Stage 1 Road Safety Audit Response Report

Project No: ITM10127
Project Title: Capitol Park, Leeds
Title: Stage 1 Road Safety Audit – Response Report (Proposed M62 Junction 28 Improvements: Full Works)
Ref: ITM10127-017B TN
Date: 17 October 2022

APPENDIX A. UPDATED SCHEME DRAWINGS –
REVISION H

Drawing Title
**MITIGATION SCHEME
FEASIBILITY DESIGN
GENERAL ARRANGEMENT**

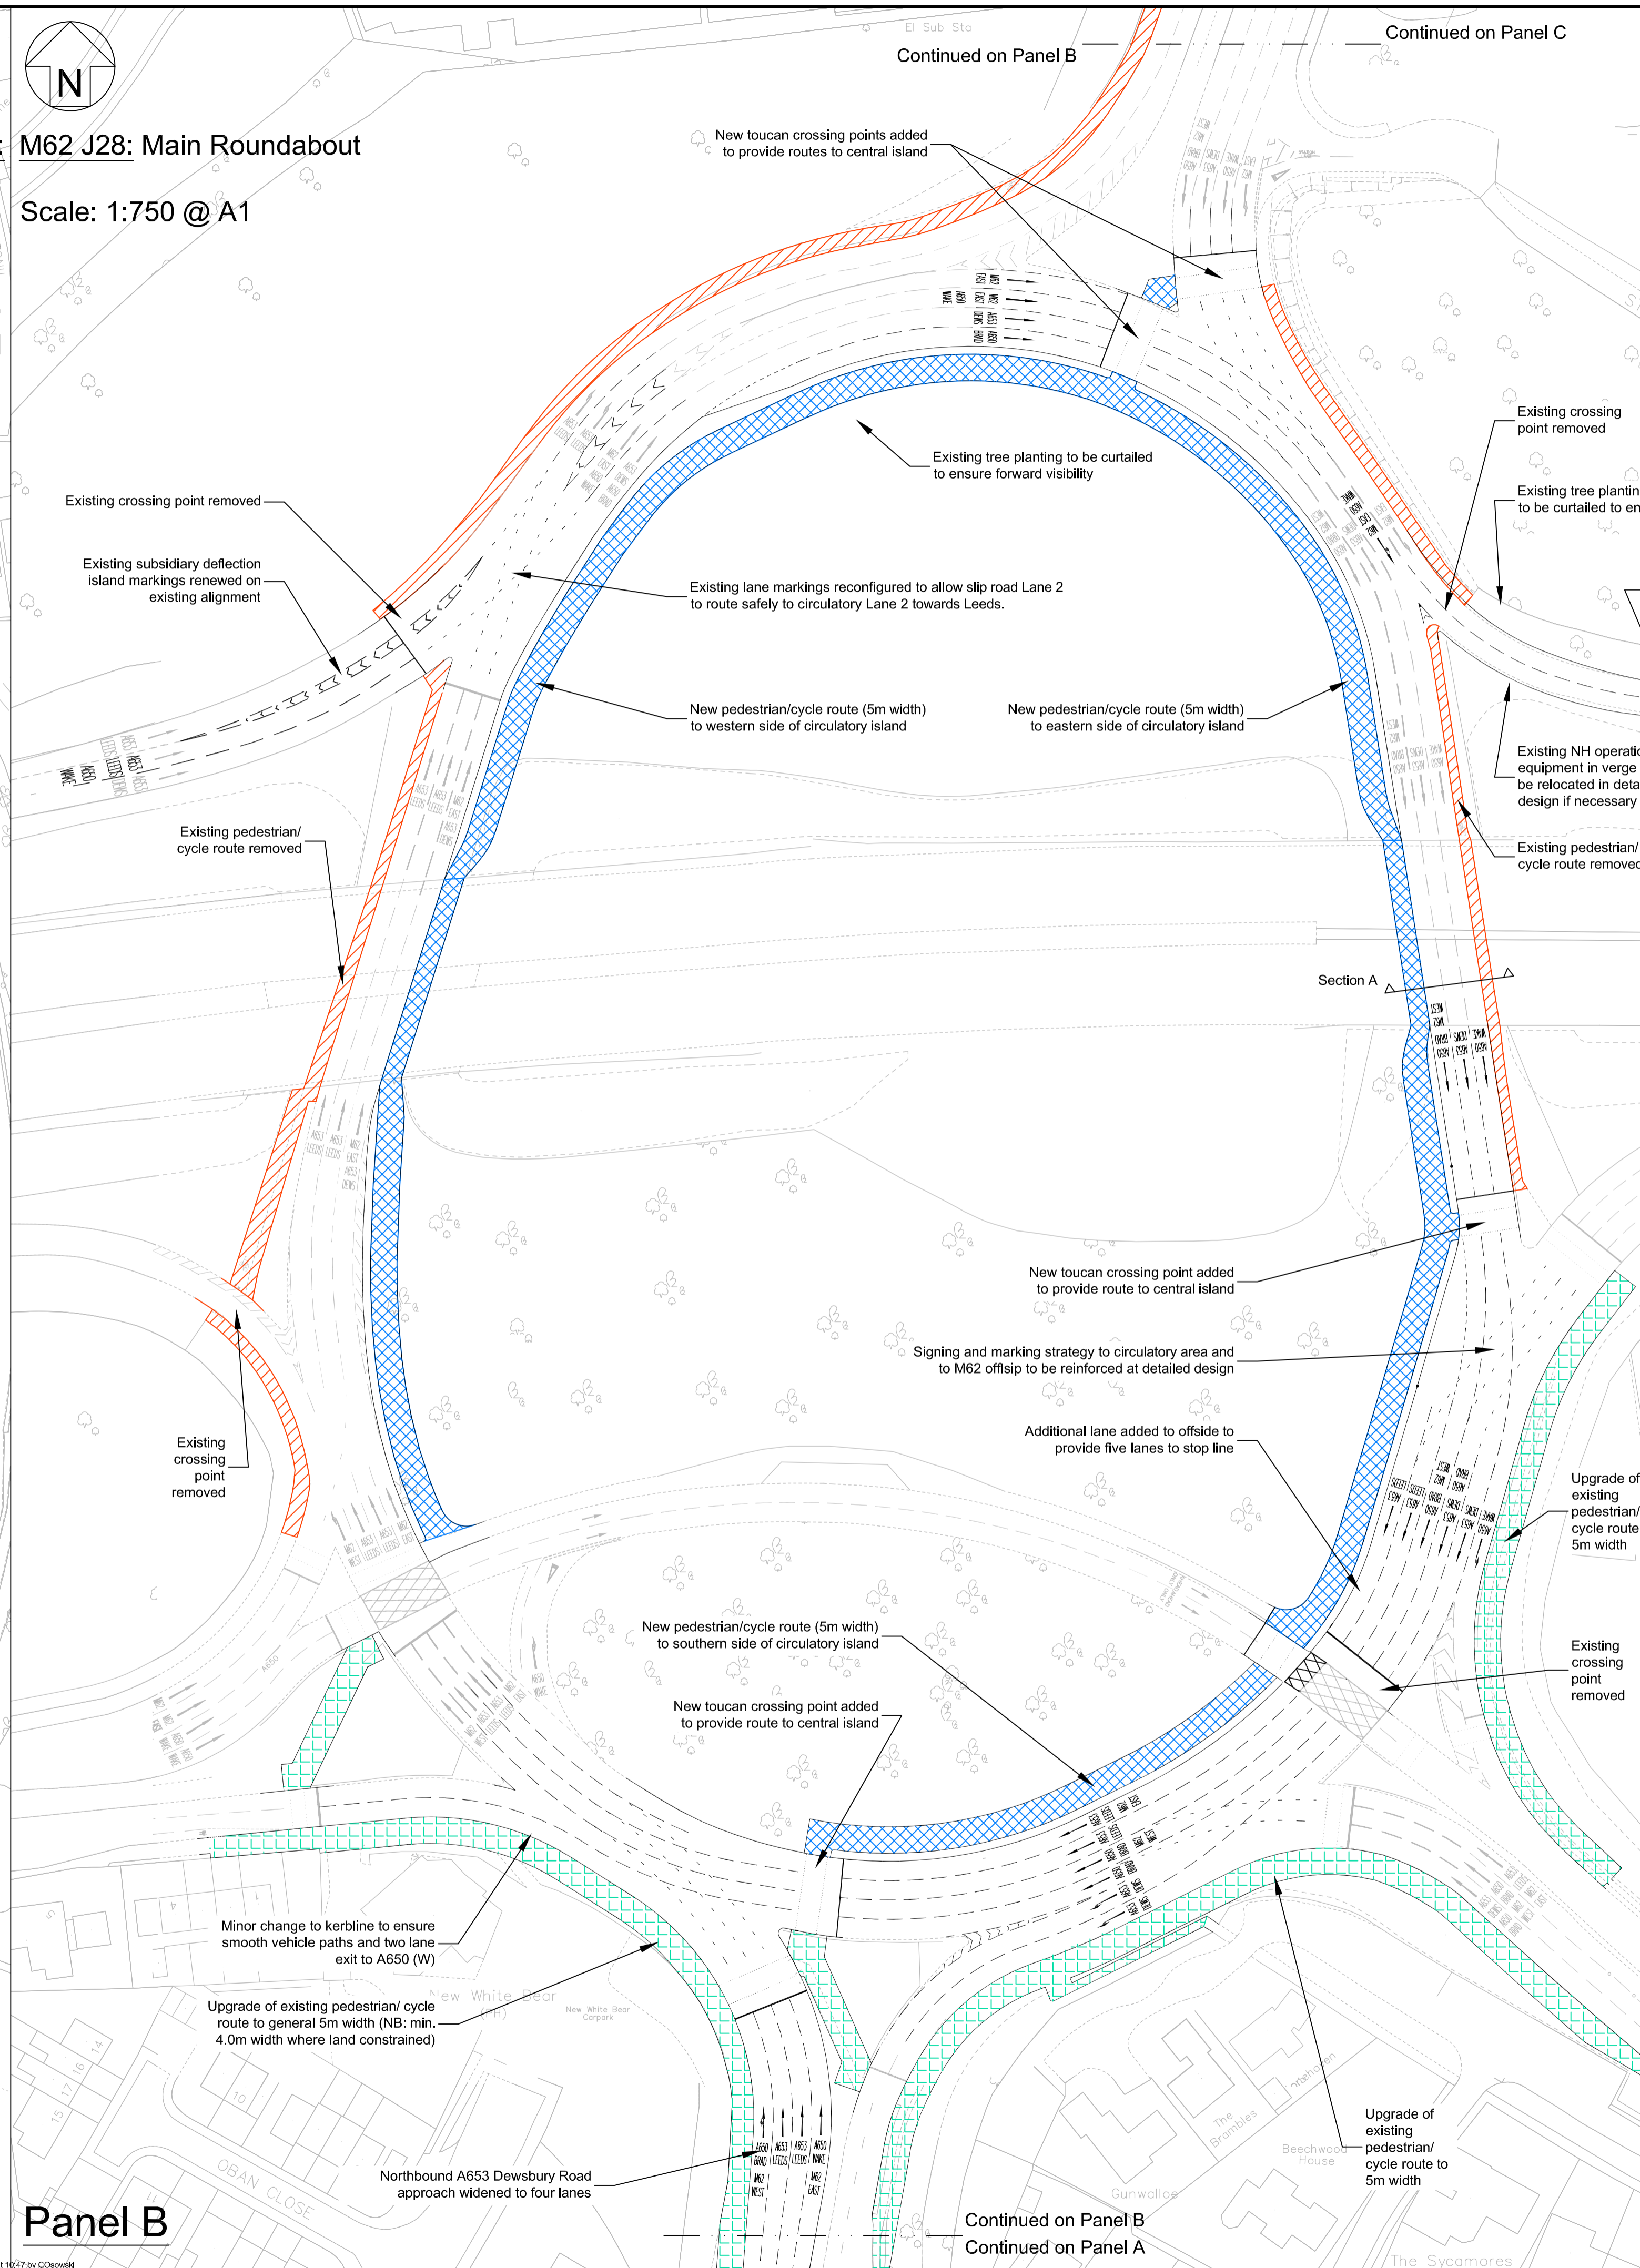
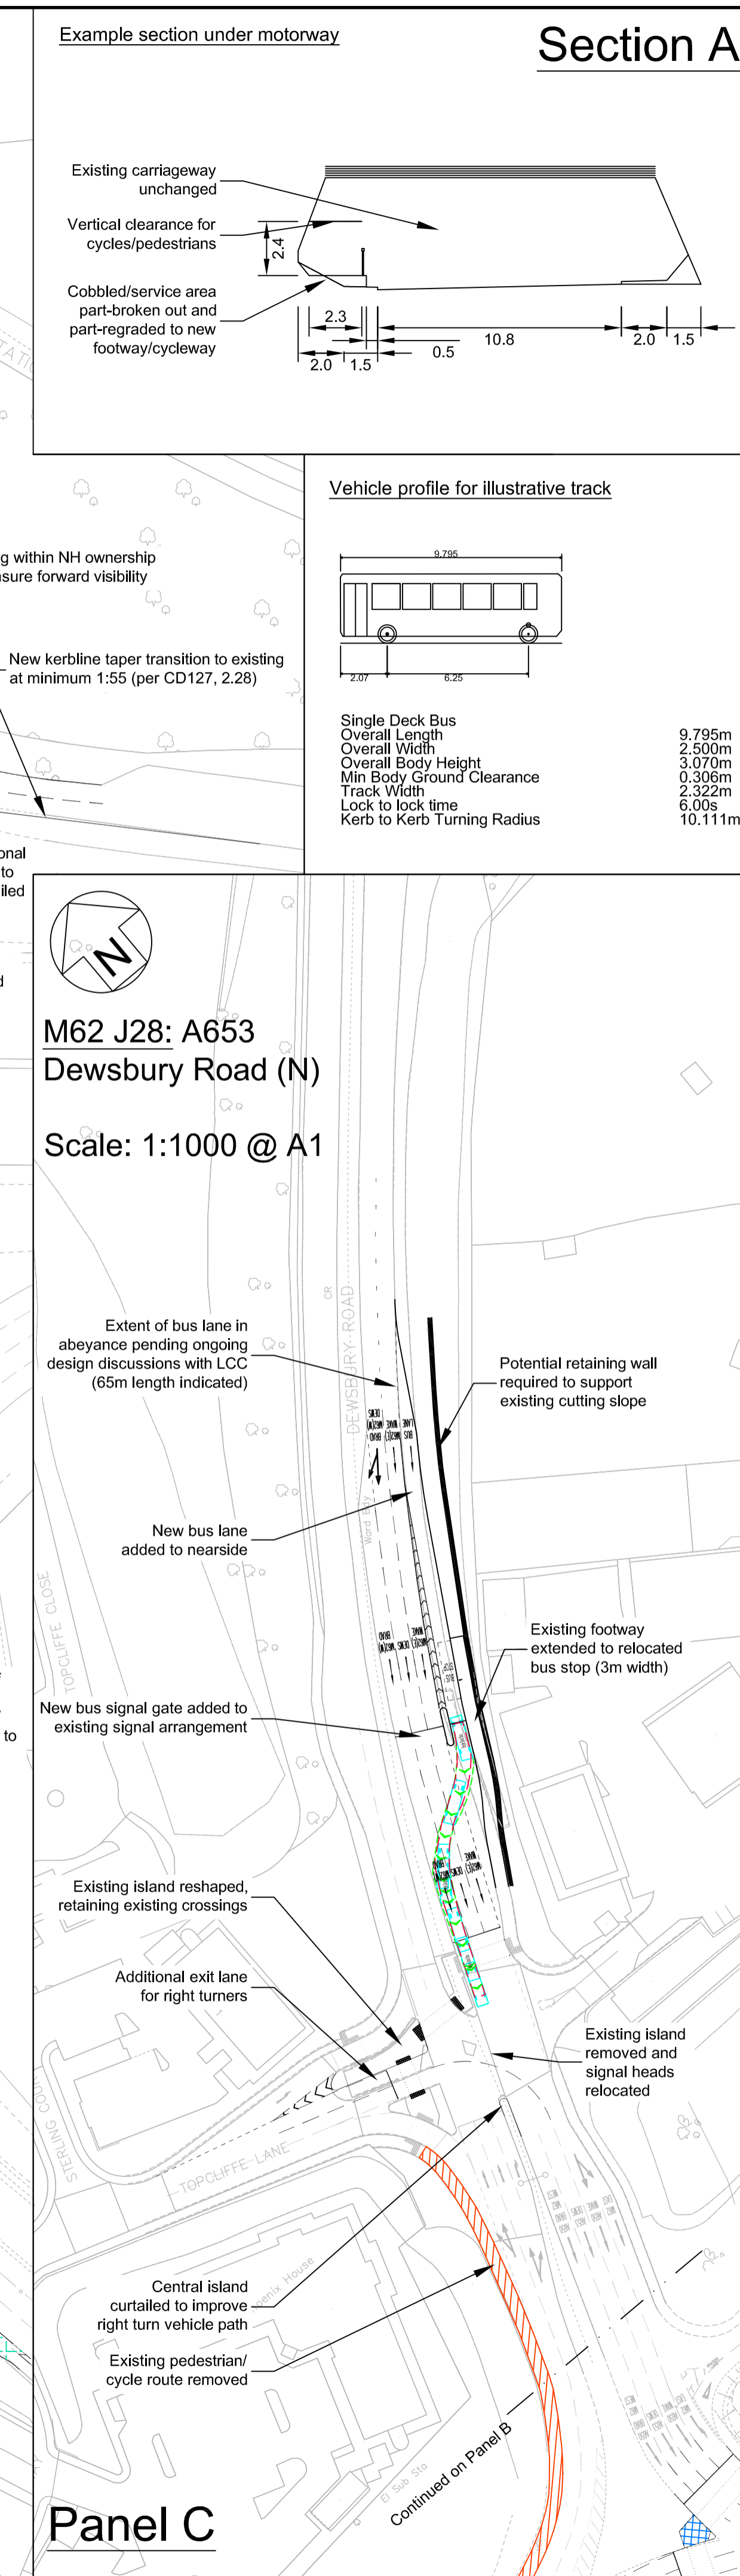
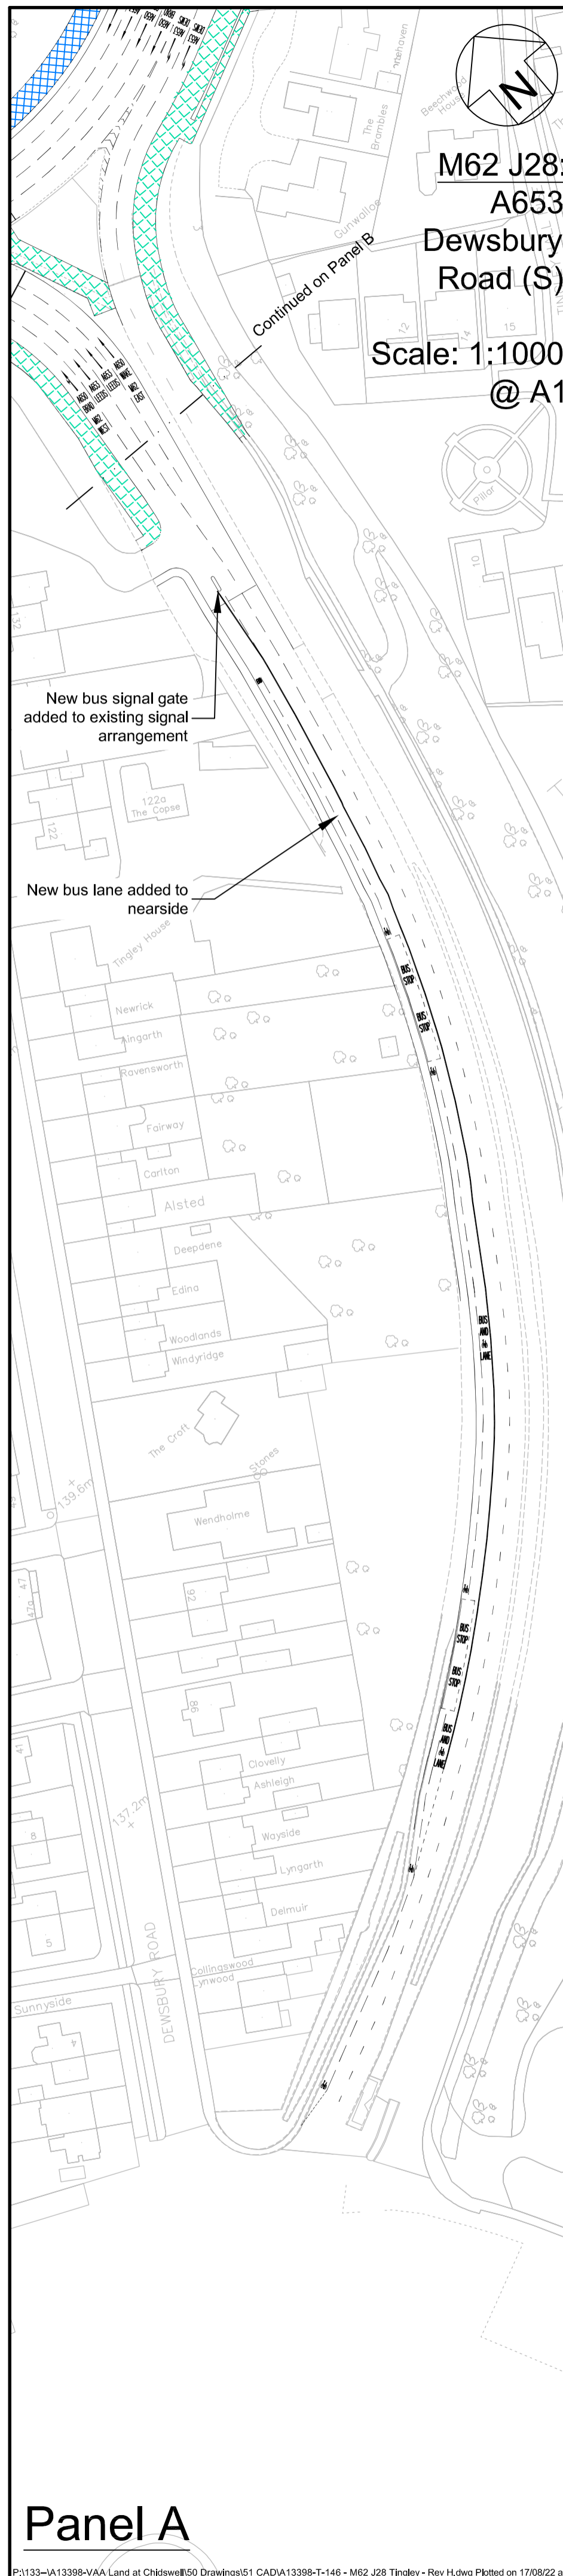
Ref:	RSA Problem	RSA Recommendation	Design Organisation Response	Overseeing Organisation Response	Agreed RSA Action
3.2	<p>Location: The Dewsbury Road northbound approach to the roundabout.</p> <p>Summary: The nearside lane marking could confuse motorists and increase the risk of collisions.</p> <p>The nearside lane worded destinations are correct (A650 and M62), but the arrow shows the lane as left-turn only. Motorists, particularly those unfamiliar with the area and intending to access the M62 west, could be led to believe that they should stay in the nearside lane, then brake and manoeuvre suddenly at the A650 exit to regain the correct lane on the circulatory on their offside. This could increase the risk of tail-end or side-swipe collisions with following motorists in that lane.</p>	<p>It is recommended that the left-turn arrow is replaced with a double-headed straight-ahead and left-turn marking.</p>	<p>The recommendation is accepted. The nearside lane marking has been amended in Revision H of the scheme drawings, enclosed at Appendix A.</p>	<p>The recommendation is accepted</p>	<p>Nearside land marking amended.</p>

REV	DESCRIPTION	DRN	CHK	APP	DATE
H	Update following Stg1 Road Safety Audit	CJO	SME/GJ	PDS/GJ	16.08.2022
G	Updated to actions of meeting 09.06.2022	CJO	SME/GJ	PDS/GJ	14.06.2022
F					
E					
D	Updated markings to JSJ/NH comments	CJO	SME/GJ	PDS/GJ	04.11.2021
C	Update to discussions with LCC/NH	CJO	SME/GJ	PDS/GJ	14.10.2021
B	Update to discussions with LCC/NH	CJO	SME/GJ	PDS/GJ	28.09.2021
